ALL OPERATORS MESSAGE

Ref. AOM: 42/72/2016/11 issue 2

Aircraft models: ATR42 and ATR72

SUBJECT: Passenger door forward handrail quick release pin

Figure 1

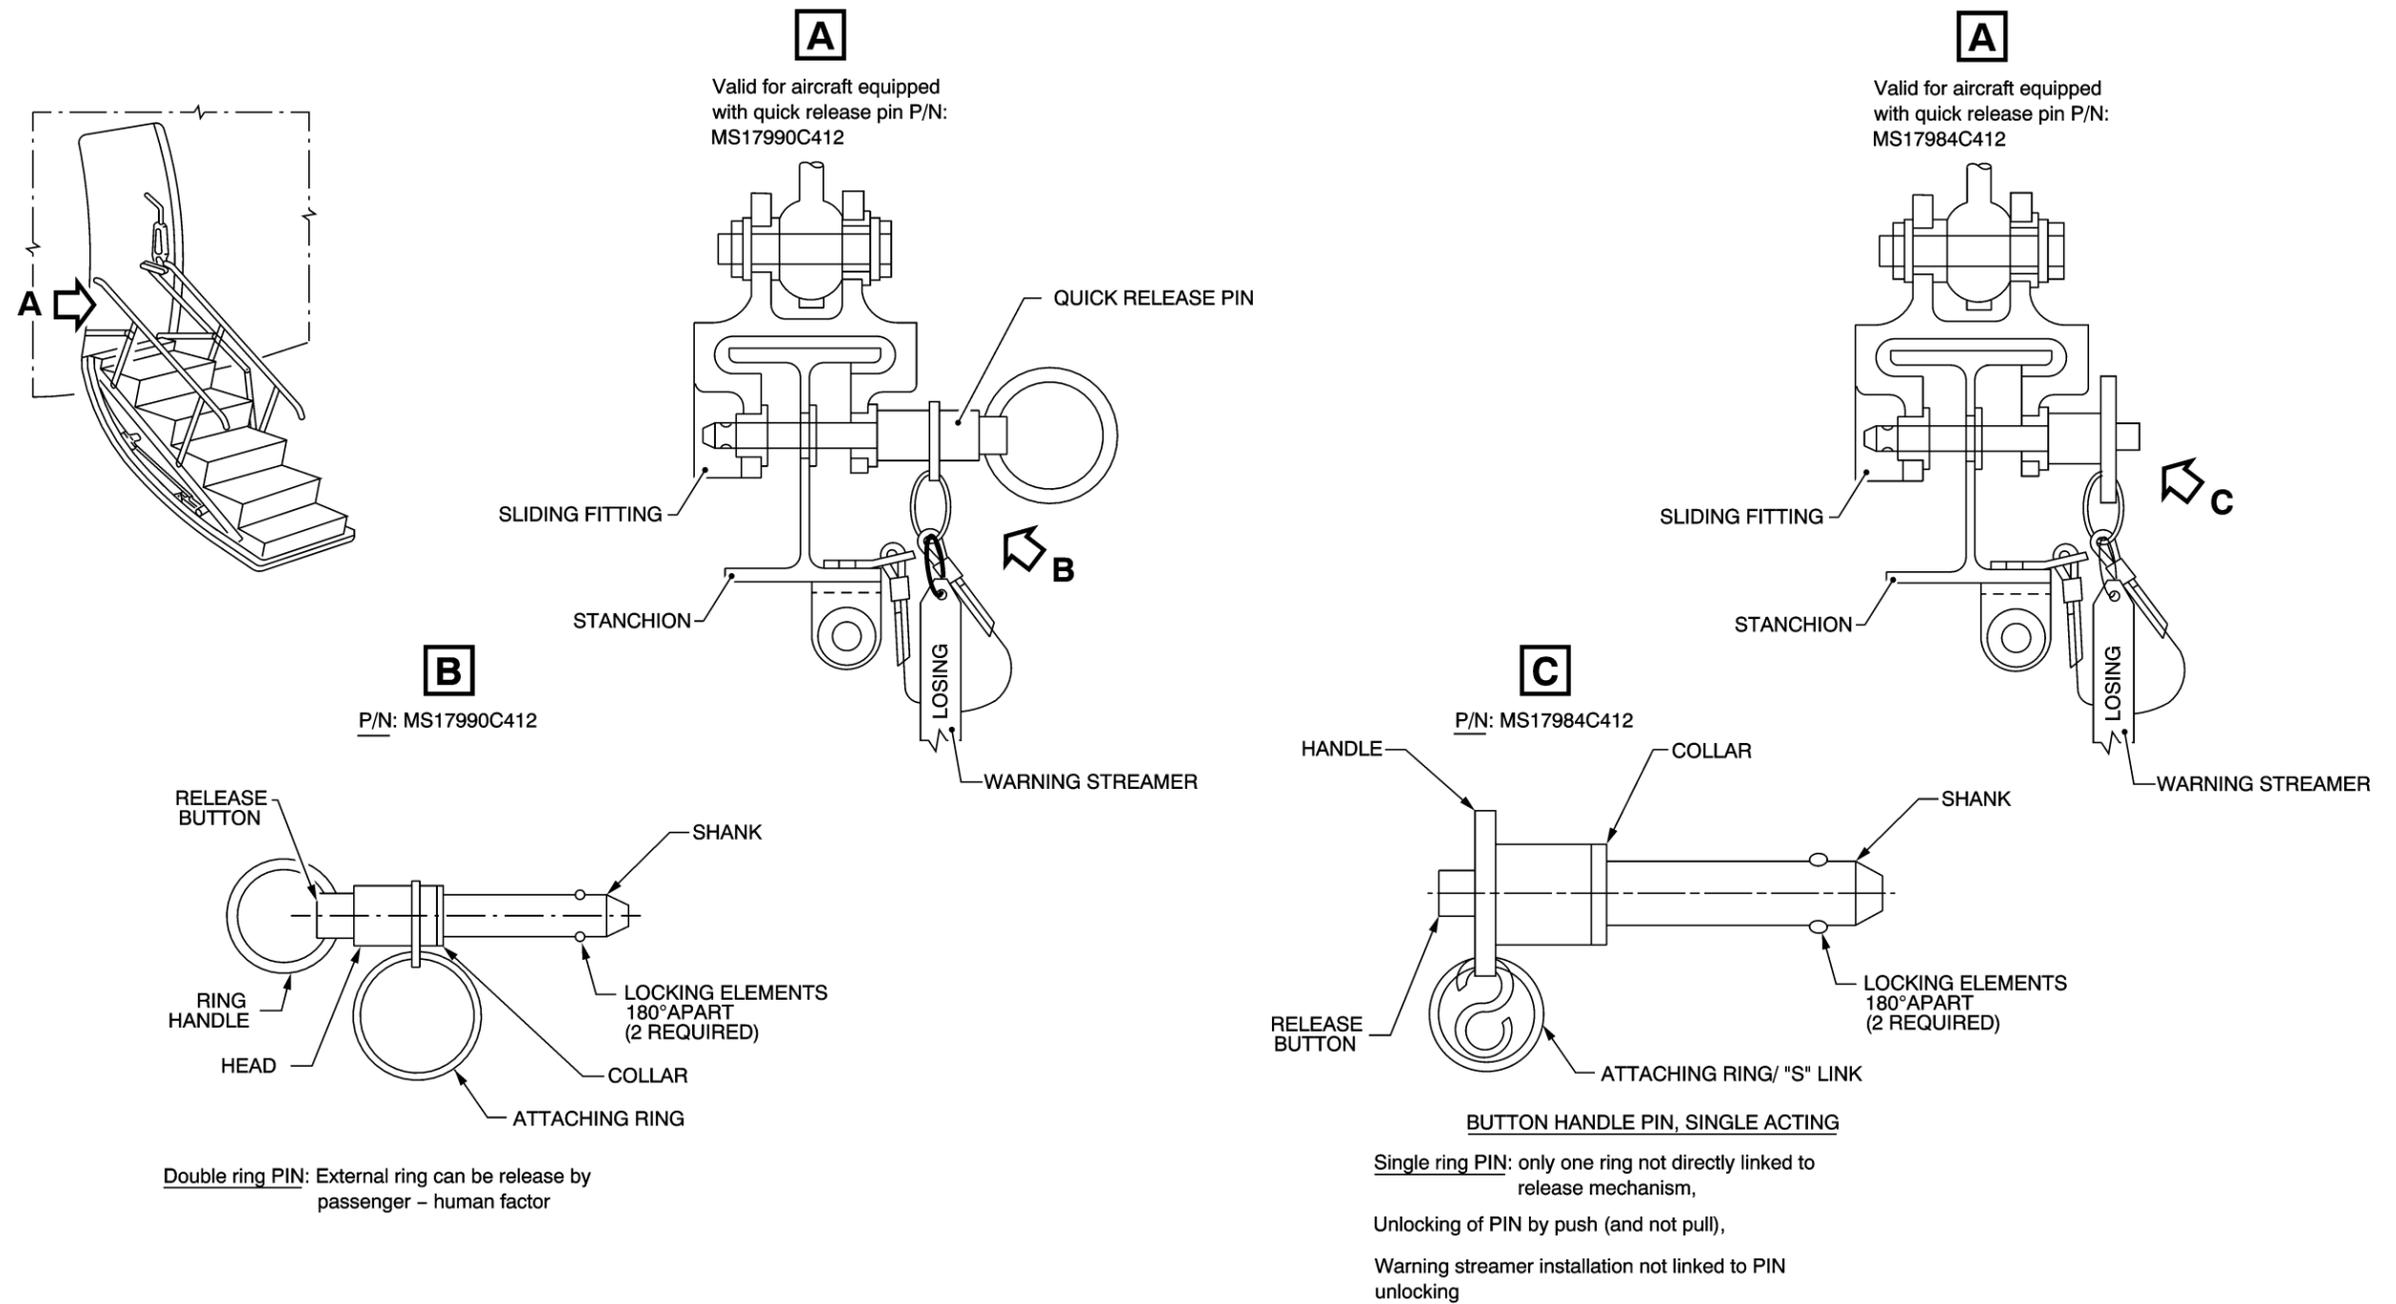
Also, the warning streamer, usually fixed to the attaching ring, was found incorrectly installed to the ring handle of pin P/N MS17990C412: in this case, if inadvertently the streamer is dragged away it can pull out the pin allowing the sliding fitting to move and the handrail to get free.

Operator maintenance staffs are also recommended to pay attention that, the quick release pin and/or warning streamer are correctly installed at attaching ring and not at ring handle specifically for pin P/N MS17990C412 as for new interchangeable pin P/N MS17984C412 warning streamer installation is not linked to pin unlocking (refer to AMM (JIC) 52-11-00 OAC 10000 and figure 1 for clarification).
